RECORD OF DECISION SUMMARY

BOWERS LANDFILL

CIRCLEVILLE, OHIO

March 24, 1989

FIGURE 6. - SITE ALTERNATIVE 4

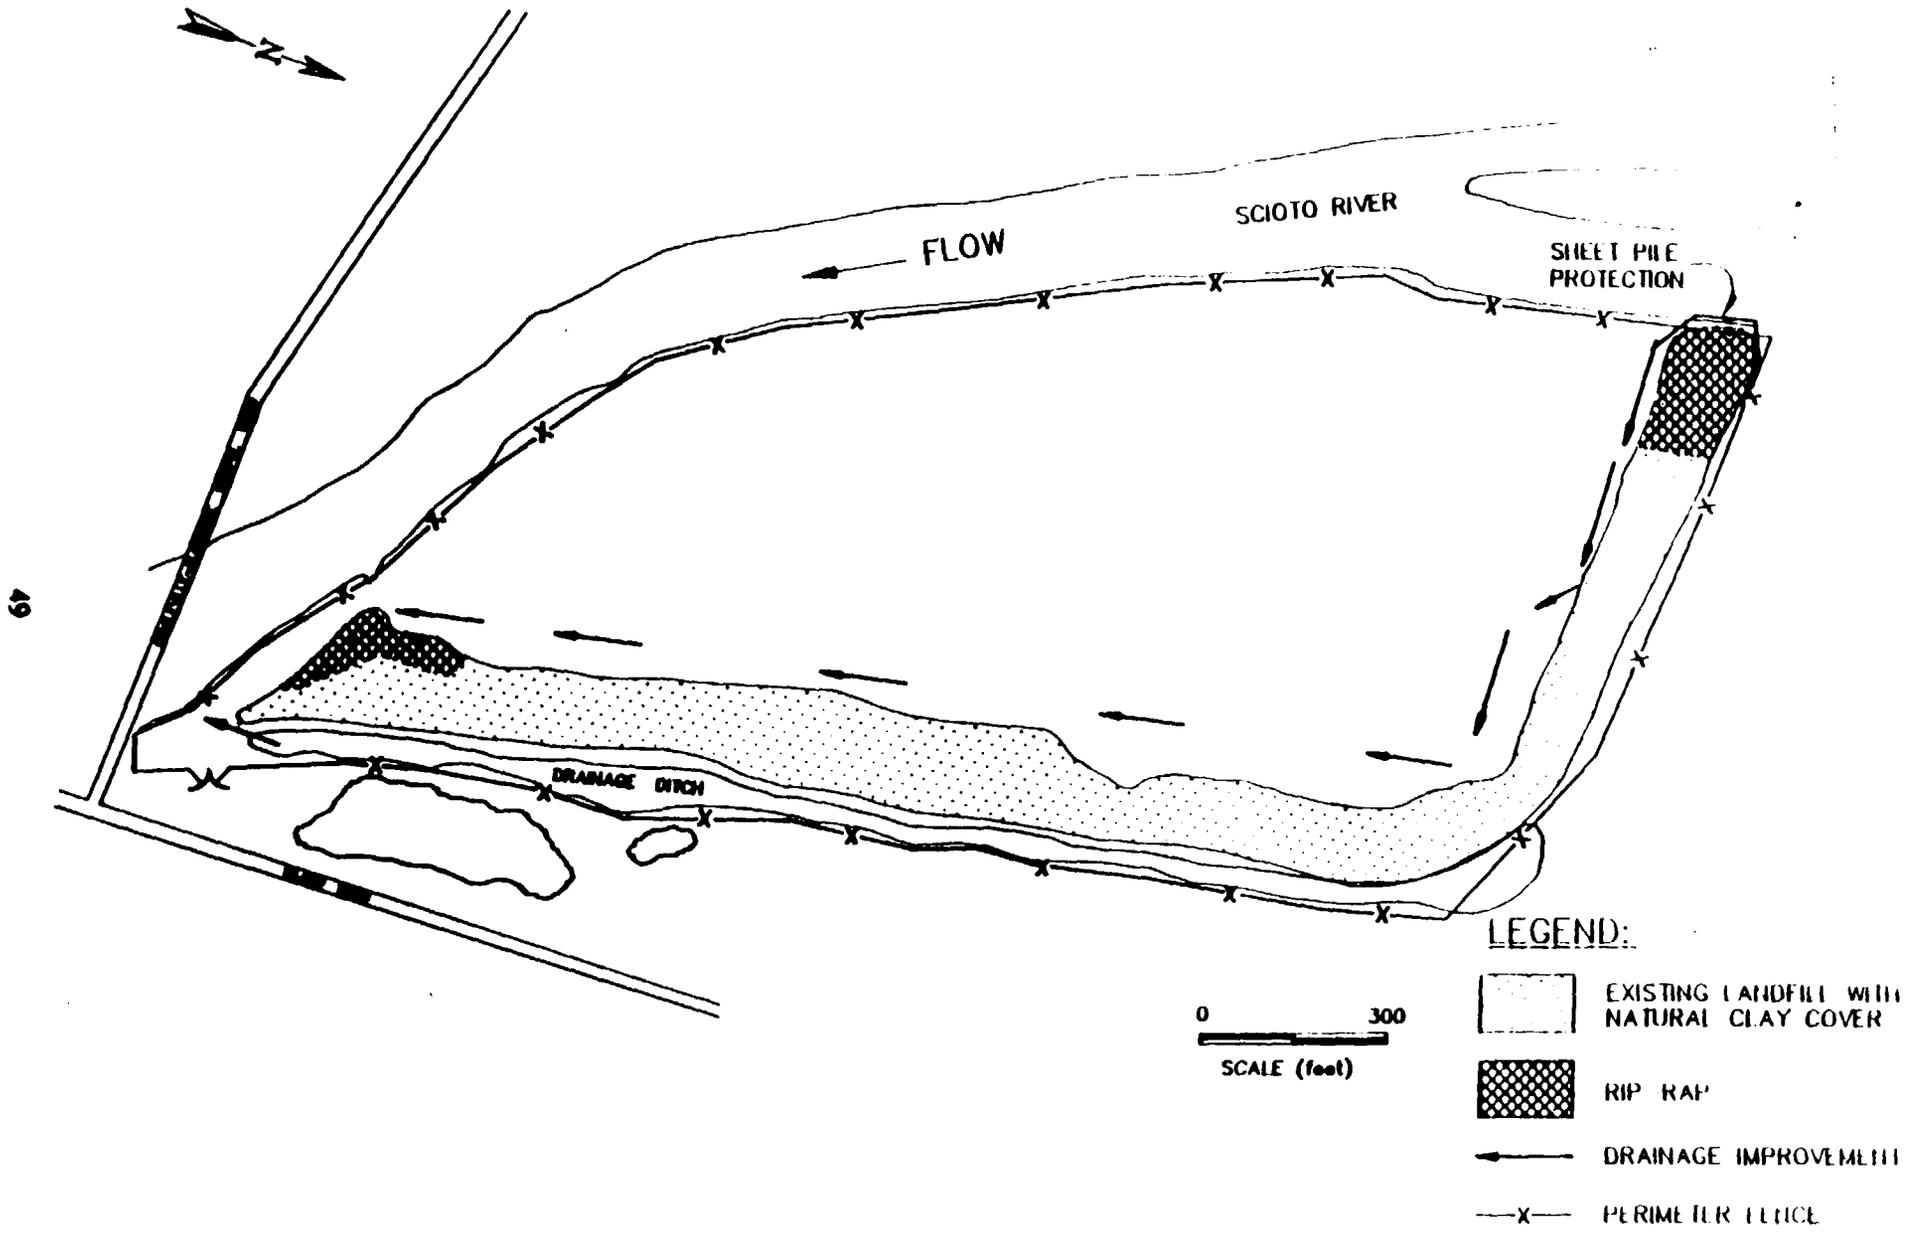
U.S. EPA Response: Based on discussions with the U.S. Army Corps of Engineers, U.S. EPA believes that the landfill cap installed under Alternative 4 can be designed and constructed to resist flood damage or washout of wastes by a 100-year flood. Alternative 4 would include flood protection, in the form of riprap, on the ends of the landfill most prone to flood damage. Where necessary, sheet piling would be added to provide additional stability. Landfill side slopes would be designed to prevent failure during flood conditions. A safe horizontal-to-vertical ratio for the side slopes would be determined by geotechnical studies of the landfill surface and the soil and clay used for the cover. Wastes would be covered by at least 4 feet of new cover material and would be isolated from flood waters. Any minor damage to the cap caused by flooding would be repaired promptly as part of an ongoing operation and maintenance program.

FIGURE 7
DETAIL OF NATURAL CLAY COVER

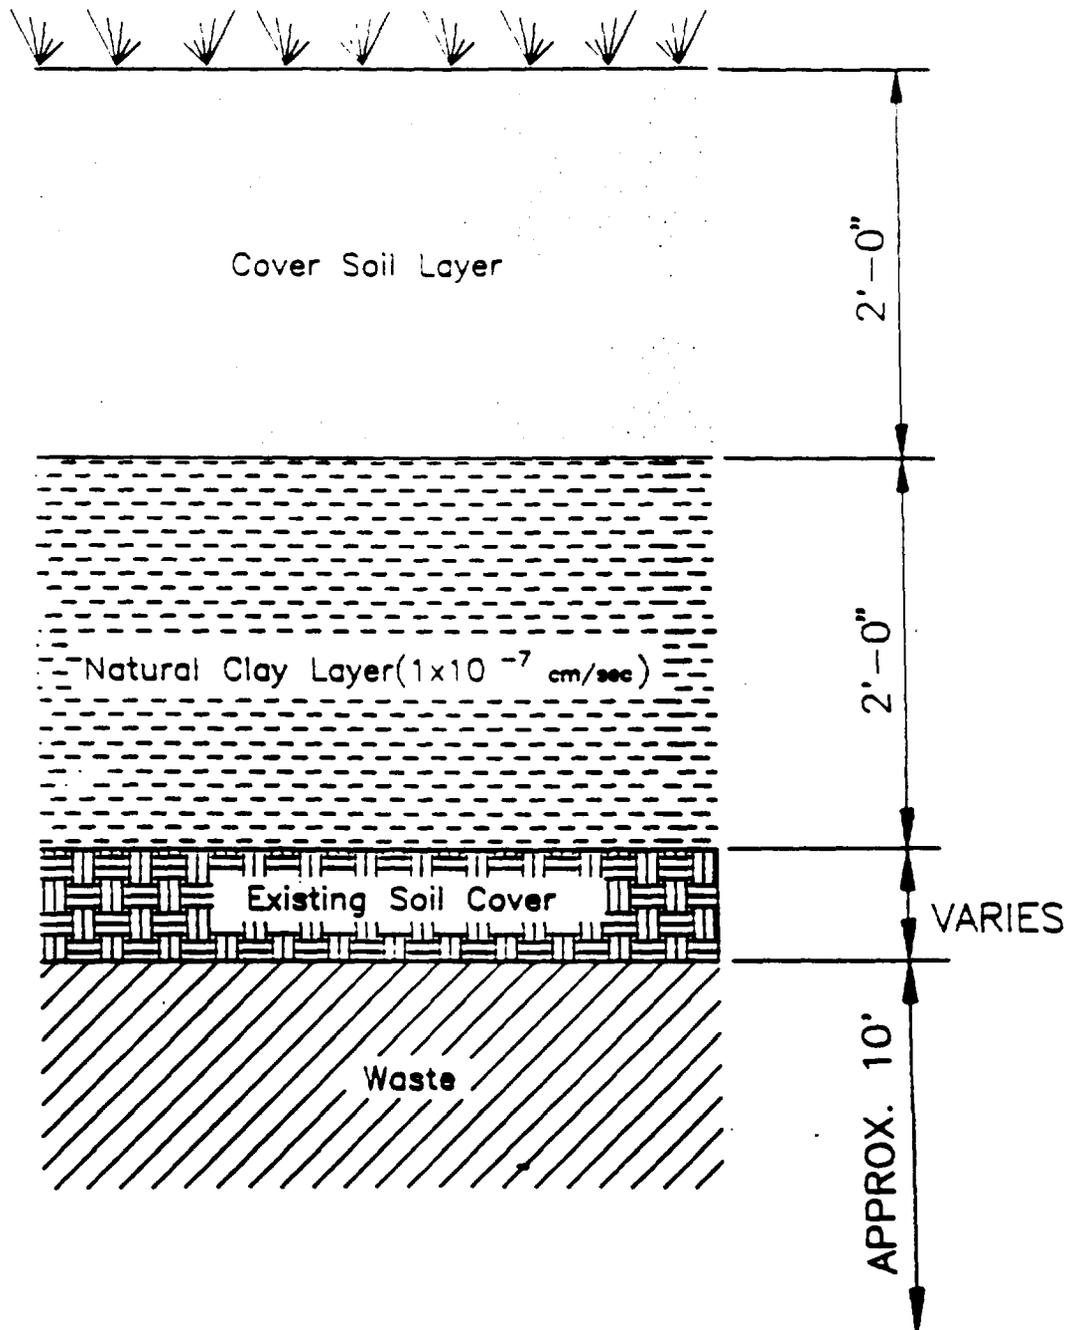
U.S. EPA Response: Capping, with either clay or synthetic membrane layers, is a standard procedure for closing land disposal units that have reached capacity. The cap serves two main purposes -- preventing direct contact and exposure to waste materials and preventing ground-water contamination by reducing infiltration of water through the wastes. The low-permeability clay cap proposed for Bowers Landfill will serve both purposes. The cap will prevent direct contact with and ingestion of contaminated soils.

U.S. EPA will take several measures to increase the effectiveness of the cap and reduce the likelihood of cap failure. First, the clay layer will be designed and installed under a strict quality assurance program. The clay will be installed in 6-inch increments (or lifts). Each lift will be compacted and tested for permeability before the next lift is added. Second, the horizontal-to-vertical ratio of the side slopes will be designed to prevent failure during worst case flooding conditions. Third, the cap will be inspected and maintained according to a regular schedule, with additional inspections scheduled after floods. If the cap leaks even after these precautionary measures are taken, the long-term ground-water monitoring program, included as part of remedial action, will detect increases in ground-water contamination before the contamination moves off-site.
